UNITED STATES PATENT AND TRADEMARK OFFICE

APPLICATION NO.	FILING DATE	FIRST NAMED INVENTOR	ATTORNEY DOCKET NO.	CONFIRMATION NO.
10/529,677	02/28/2006	Peter John Bisiules	90959US	8431

Office Action Summary	Application No.	Applicant(s)	
	10/529,677	BISIULES ET AL.	
	Examiner	Art Unit	
	Trinh Vo Dinh	2821

DETAILED ACTION

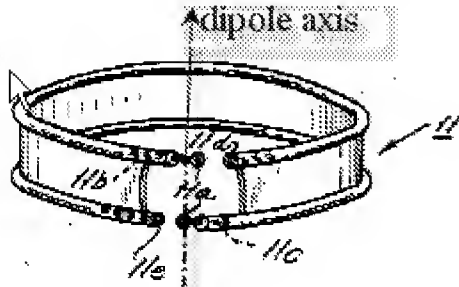
Respecting claim 1, Snow discloses, in Figs 2-3, a folded dipole (11) having a dipole axis and a pair of arms (inner arm 11b, outer arm 11c) which together have a profile which is concave on one side and convex on the other when viewed along the dipole axis.

Respecting claims 2-4 and 9, Snow discloses the arms are at least partially curved, the arms have curved portions which have a substantially constant radius of curvature, and the arms are at least partially curved in a plane substantially orthogonal to the dipole axis. Snow further discloses an input section (11a, 11d) coupled to a concave side of the pair of arms.

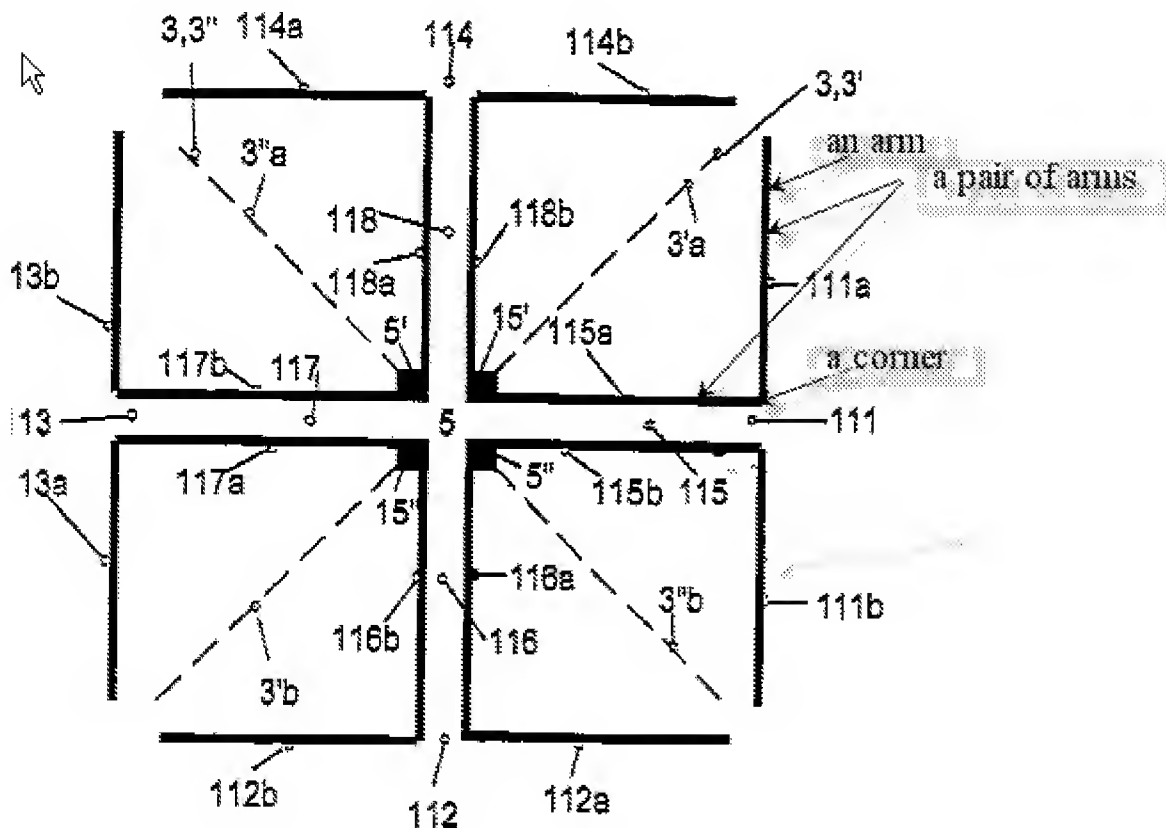
Respecting claim 1, Dienes discloses, in Fig. 1, a folded dipole having a dipole axis and a pair of arms (10 + 12) which together have a profile which is concave on one side and convex on the other when viewed along the dipole axis.

Respecting claims 2-4 and 9, Dienes discloses the arms are at least partially curved, the arms have curved portions which have a substantially constant radius of curvature, and the arms

are at least partially curved in a plane substantially orthogonal to the dipole axis. Dienes further discloses an input section (14) coupled to a concave side of the pair of arms.

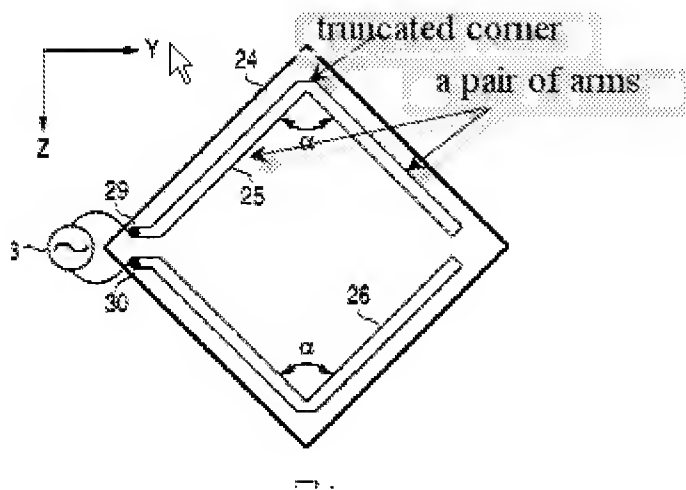
Respecting claim 1, Gabriel discloses, in Figs 2 and 5, a folded dipole (111) having a dipole axis and a pair of arms (one of 111a, 111b, 112a, 112b, 113a, 113b as shown in the below drawing) which together have a profile which is concave on one side and convex on the other when viewed along the dipole axis.

Respecting claims 5-7, 9-11, Gabriel discloses, in Figs. 2, 5, the pair of arms meets at a corner that subtends an angle lying in the range of 80° to 100° , each arm is substantially straight. Gabriel further discloses an input section (15', 5', 5'', and 15'') coupled to a concave side of the pair of arms, the pair of arms and both arms are inherently formed of sheet material and from the same sheet.

Respecting claims 16-20, Gabriel discloses, in Fig. 2, a dipole box comprising two or more folded dipoles (111a+111b, 112a+112b) arranged around a central region, each folded dipole having a dipole axis and a pair of arms (111a, 111b) which together have a profile which is concave on one side and convex on the other when viewed in plan perpendicular to the central region, each pair of arms has a curved portion with a centre of curvature which is located in the central region. Furthermore, Gabriel discloses four or more folded dipoles (111a+111b, 112a+112b, 113a+113b, 114a+114b) arranged around the central region, the dipoles are arranged as orthogonally opposed pairs, and each pair of dipoles is oriented at about $\pm 45^{\circ}$ with respect to vertical (Figs 2 or 5).
